STORMWATER MANAGEMENT FACILITIES OPERATION AND INSPECTION REPORT

Quarter Section SE 1/4 Sect 29 Name of Business/Subdivision Spencer's Pass
 Property Tax ID Number 0116-059 Address of Property East Subdivision

Description: SWP 29 s001 Location Of Pond North of Fox River Way
Tear drop shape in Outlot 4 of Spencer's
Approx. 2 acres in size Pass East Subdivision

RE: Carter's Crossing and Spencer's Pass Pond Recertifications

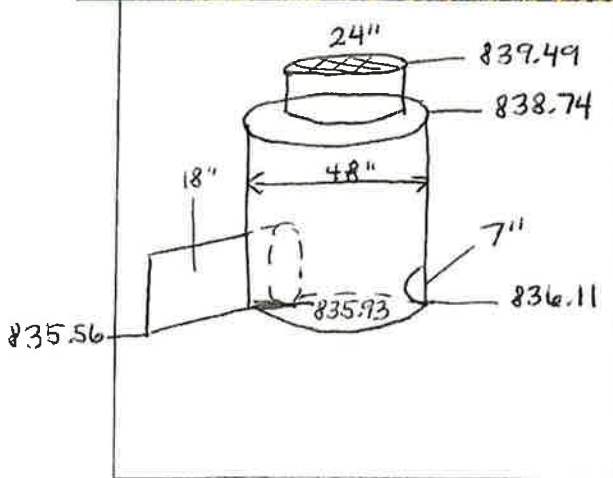
Compliance Verification	Design	Actual	Compliant Yes No	Comments (Condition of Structure)
Primary Outlet Pipe				
Opening Diameter	15"	18"	X	Larger diameter increases the amount of flow allowed to leave the pond.
Upstream Invert	836.2	835.93	X	Invert 3" lower.
Downstream Invert	—	835.56	X	
Length	—	78'	X	
Slope	—	.005	X	
Secondary Outlet Pipe (If Applicable)				
Opening Diameter				
Upstream Invert				
Downstream Invert				
Length				
Slope				
Riser (If Applicable)				
Opening Diameter	—	24"		
Elevation	840.00	839.49	X	A 0.5' lower riser means runoff discharges faster sooner.
Upper Discharge Control (If Applicable)				
Opening Diameter				
Elevation

Compliance Verification	Design	Actual	Compliant Yes No		Comments	
Lower Discharge Control	(If Applicable)					
Opening Diameter	7"	7"	X			
Elevation	836.20	836.18	X			
Other (Description)	NA					
Opening Type						
Elevation						
Emergency Spillway						
Elevation	844.75	844.73	X			
Length of spillway		10'	X		The length of spillway does not appear to have been defined in the design. A 10' width should be adequate.	
Embankment			Present Yes No			
Unauthorized plantings, trees, or woody vegetation				X		
Animal burrows or slope erosion				X		
Storage Properties	Design	Actual	Compliant Yes No		Points Surveyed	Equipment Used
Normal Water Elevation (Wet Ponds)	836.20	836.18	X			Design - From original report Actual -
Design High Water Elevation	844.75	844.73	X			
Area at Normal Water Elevation (Ac) (Wet Ponds)	0.525	0.511	X			Calculated area in AutoCAD drawing based on surface from surveyed points.
Area at Design High Water Elevation (Ac)	1.373	1.358	X			"

Active Storage Available (Ac-Ft)*	6.436	6.316	X			
Lowest Elevation at Top of Embankment (If Applicable)	844.75	844.73	X			
Average Elevation at Top of Embankment (If Applicable)	845.75	845.75	X			
Maximum Bottom Elevation	831.20	830.68	X			
Average Pond Bottom Elevation	831.20	831.20	X			
Pond Bottom Area (Ac)	0.123	0.041	X			Although the pond bottom is smaller, there is still an average of 5' depth
Maximum Pond Depth	5'	5.5'	X			
Average Pond Depth	5'	5'	X

Pond 6P: REVISED POND

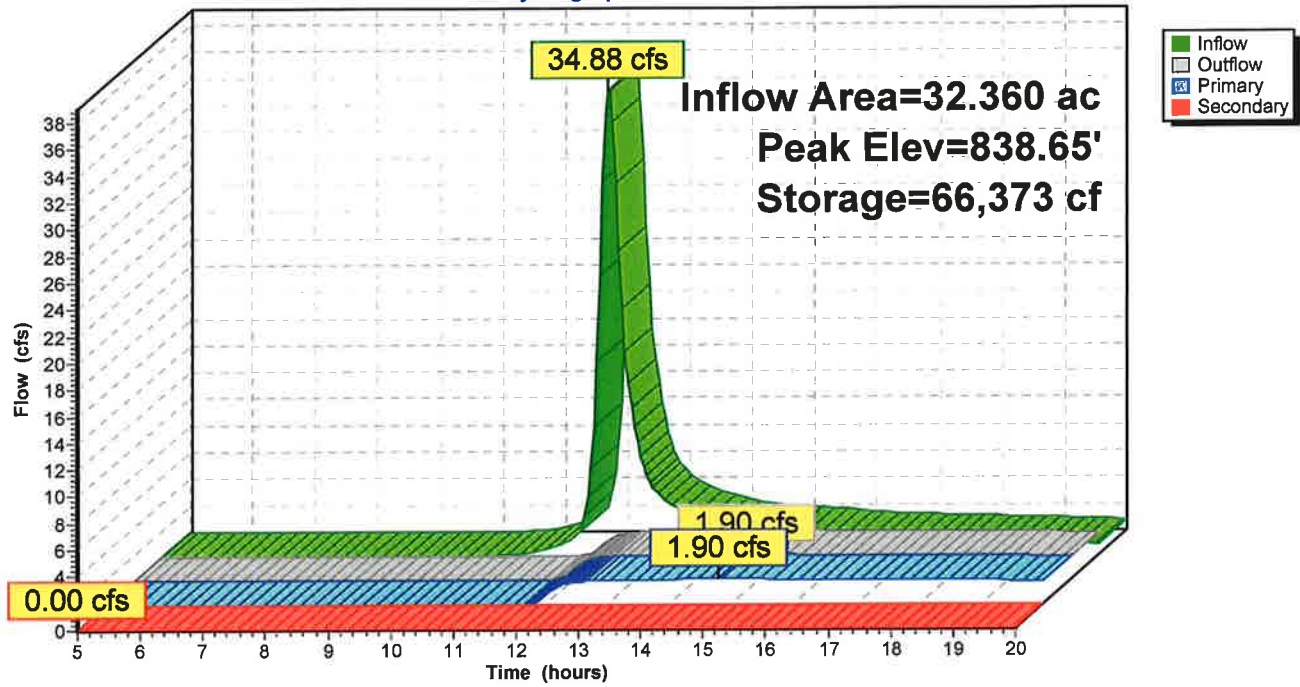
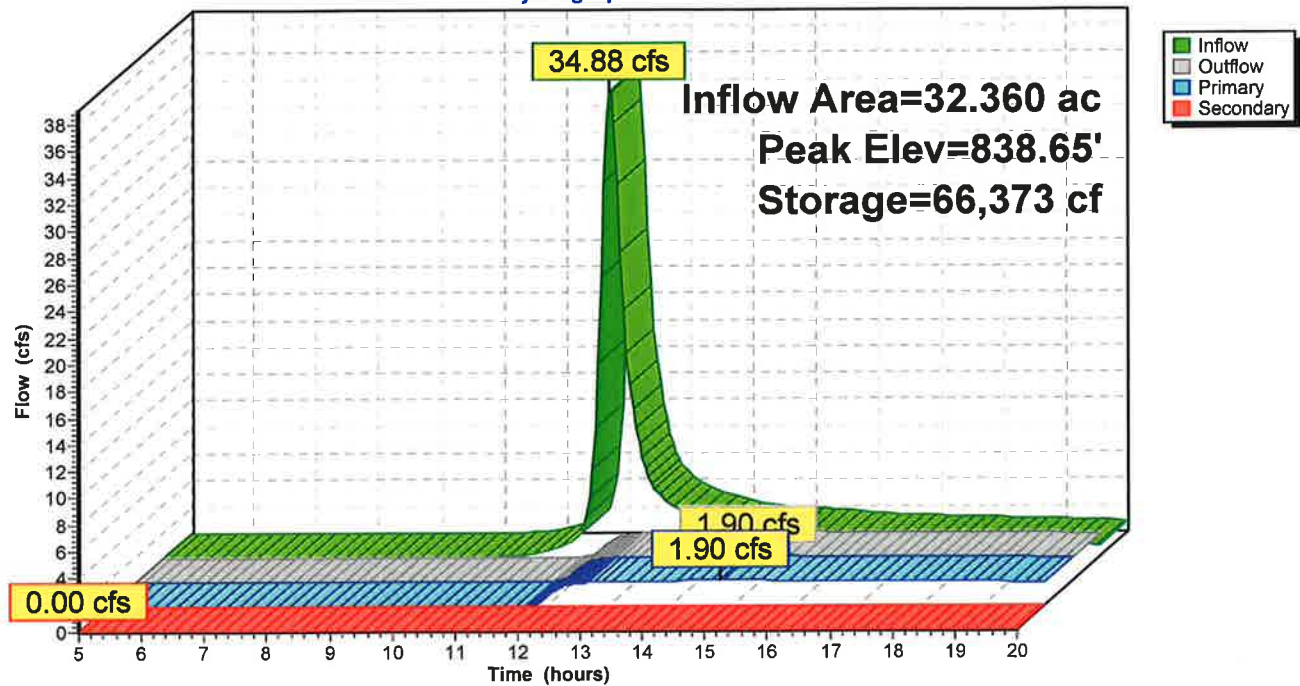
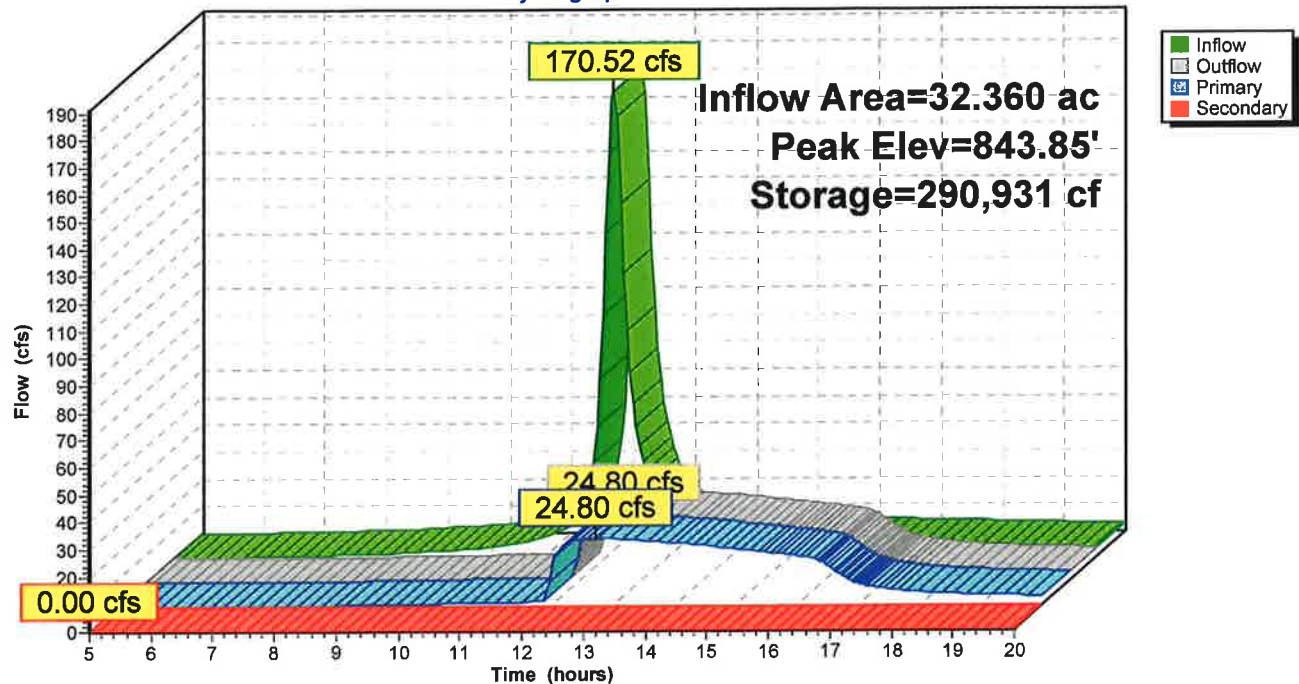
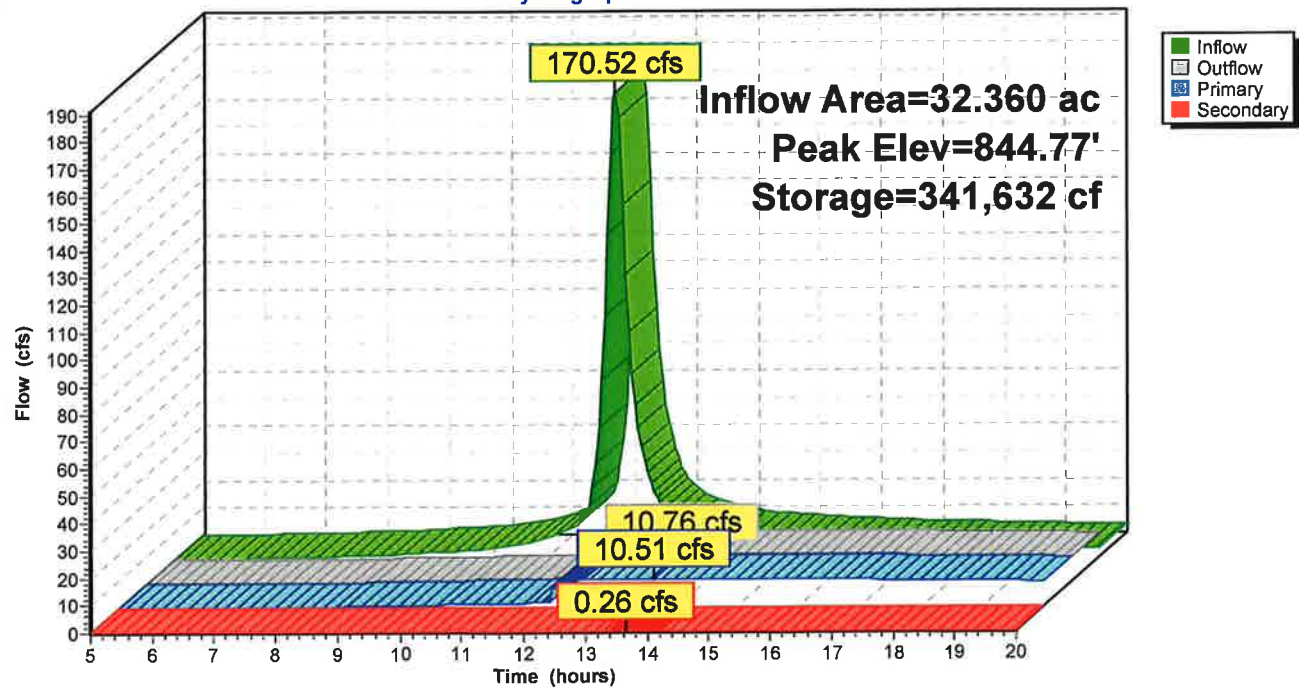
2 year = 1.90 cfs
100 year = 24.80 cfs

*Restrict
18" Discharge
Pipe to
12"*

2 year = 1.90 cfs
100 year = 10.76 cfs
